## **HINCKLEY NATIONAL RAIL FREIGHT INTERCHANGE**

### **The Hinckley National Rail Freight Interchange Development Consent Order**

### **Applicant's response to Deadline 5 Submissions [part 3 - LCC]**

Document reference: 18.19

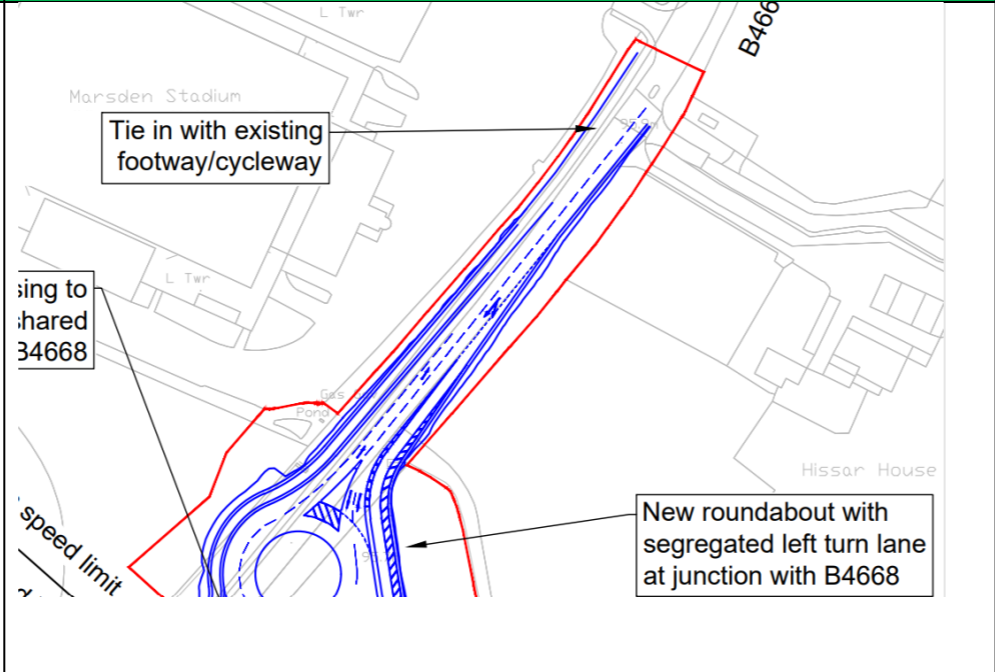
AP No	Action	LCC Response	Applicant's Response
123	Continuous review of local junction models and engagement with Applicant, with particular regard to furnessing	<p>LCC are aware that the Applicant has commissioned new surveys at junctions where off-site mitigation is proposed only. At a meeting held on 2nd February 2024, LCC, NH and WCC requested that the Applicant team make this data identifiable on the shared Sharepoint site.</p> <p>At this meeting, the Applicant team committed to various actions in respect of providing clarification on the furnessing methodology used. These include:</p> <ul style="list-style-type: none"> <li>• Applicant team to provide clarifications on calculations and the application of the methodology</li> <li>• Applicant to provide a note addressing discrepancies between old and new survey data (noting differences between target and observed flows)</li> <li>• Applicant team to check that demand inputted included for traffic queuing, not just that passing a stop line.</li> <li>• Applicant team to model Gibbet roundabout in VISSIM and present the results to the Highway Authorities (as requested in REP1-152)</li> </ul> <p>Timescales for the above rest with the Applicant. Whilst awaiting this information, LCC is pressing ahead with its review of the survey data to check that it has been correctly transferred into the furnessing spreadsheet. LCC will be in a position to confirm to the ExA if this is the case at Deadline 6.</p> <p>In respect of overall junction models, these cannot be agreed until the outstanding furnessing matters have been addressed by the Applicant, and LCC have confirmed that data has been correctly inputted. LCC would expect that the Applicant would address this in a timely manner given the impending examination end date, and LCC are hopeful that we will be in a position to agree furnessing methodology by 12th March 2024.</p>	<p>These actions do not align with the agreed list of actions arising from the meeting. The actions shared with the TWG by the Applicant following the meeting on the 02 February were as follows- there was no further feedback on these points and appear to differ from those set out by LCC. Furnessing. The full action list is:</p> <ul style="list-style-type: none"> <li>• BWB to review Gibbett vehicle turning proportions within Junctions 10 model as a sensitivity test. <i>Done and provided to NH on 07 February</i></li> <li>• BWB to check the survey data to allow for demand flows and queuing. <i>This was checked with the survey team and confirmed, queue length surveys were also recorded. All survey data was signposted on 02 February.</i></li> <li>• M69 mainline flows clarity on how these were furnessed for the VISSIM at J2. <i>This was shared with the TWG on 05 February</i></li> <li>• AECOM to provide VISSIM (standalone) for Gibbett. <i>Not received- no model exists. Confirmed by NH on 02 February. A corridor model previously sent by NH is the only model held on file.</i></li> <li>• Any clarifications to be dealt with directly via technical consultants. Noted- further conversations/ correspondence with respective teams.</li> <li>• BWB to ensure Sharepoint folders are in logical order. <i>This was done and reported on 02 February</i></li> </ul> <p>The Applicant maintains that the original 2019 survey flows provided a robust base for the furnessing approach- much of the preparation for the submission was done under post-covid conditions which were not deemed robust previously. It was the insistence of the TWG for updated flows for 2023 that has further delayed the ability to review in depth.</p>
